RE: **Percolation Testing Report**
14084 Barbara Circle
Tax Map 08; Parcel 203
Cooksville, MD 2172384

RE: Villa Monticello – Lot 6
14084 Barbara Circle
CLSI Job No.: 2023296

TO: CLSI
RE: 14084 Barbara Circle (Villa Monticello – Lot 6)

RE: **Percolation Certification Plan Proposal**
14084 Barbara Circle, Lot #6
Cooksville, MD 21723

PROPOSED SDA
(5,330 SQ. FT.)

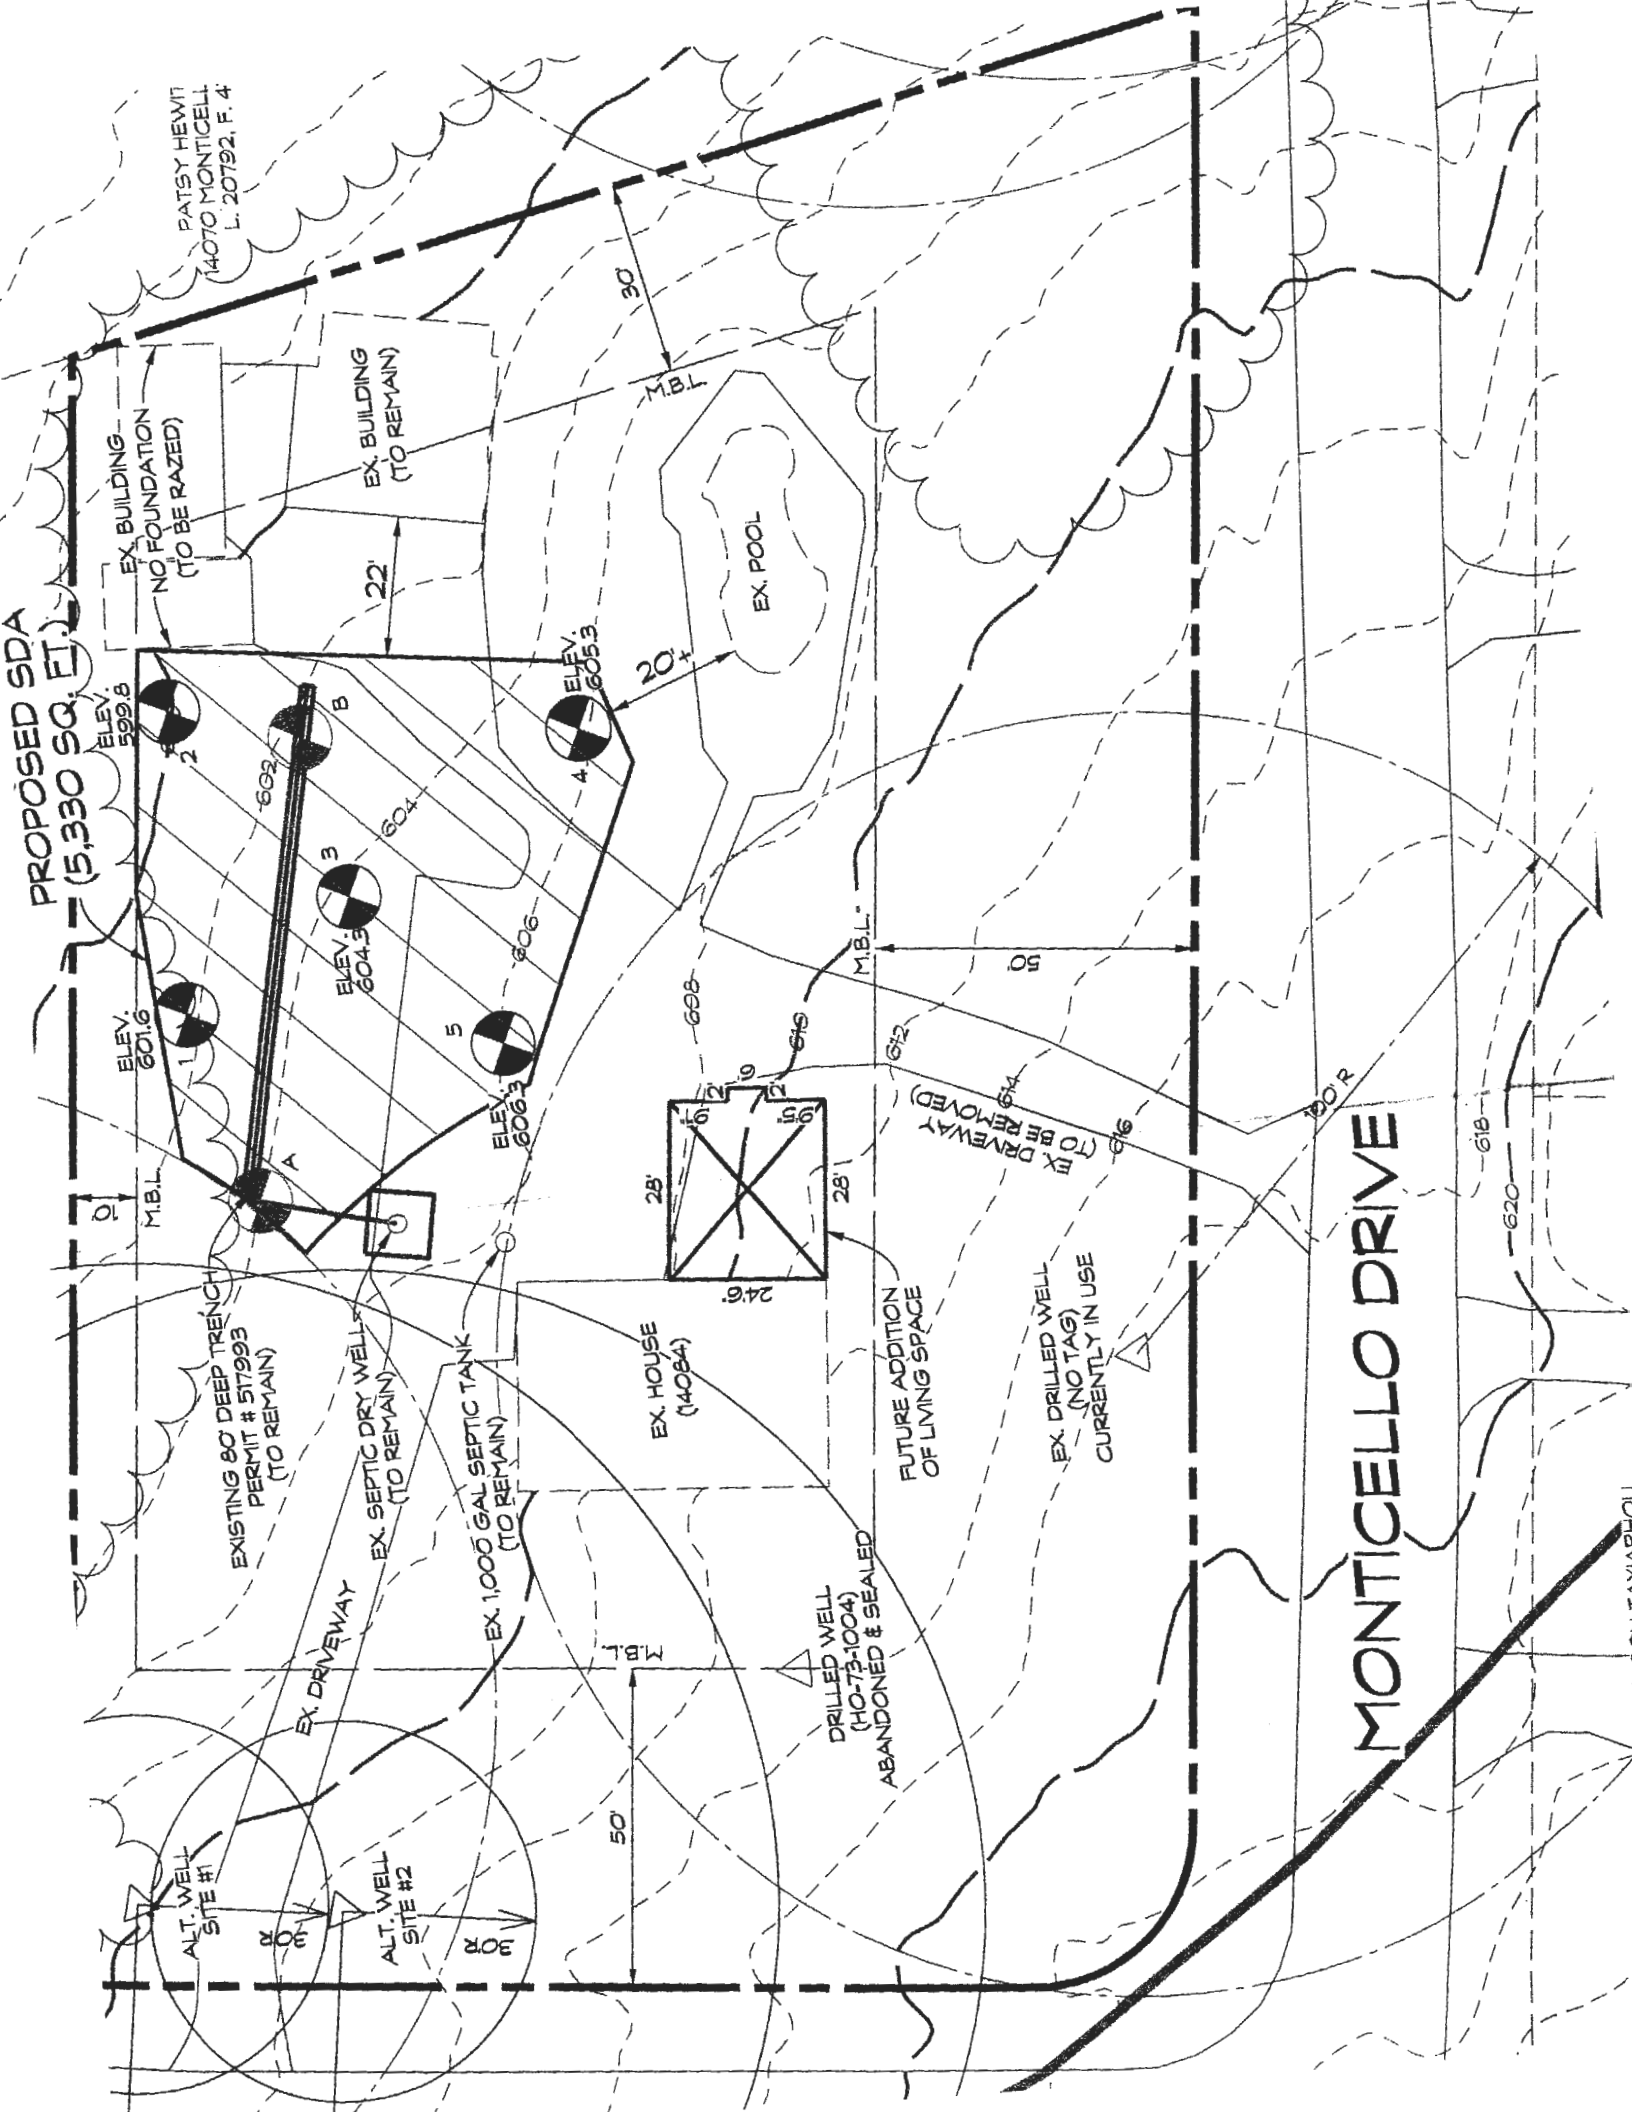
I have also attached a picture of an SDA reconfiguration. (see above) Just looking to expand and get the most use out of the area, the paved driveways are a big concern.

3. I attempted to move around some of the perc holes to maximize the area.
 - a. I don't know how we're expected to conduct excavation at proposed perc pit #5 & possibly #4.

3. Proposed perc tests #4 and #5 will be conducted through the existing driveway. This portion of the driveway is to be removed in the future as well as the driveway entrance extending from Monticello Drive. Any paving within the proposed Sewage Disposal Area (SDA) and the paving extending back to the existing garage and sheds is to be removed.
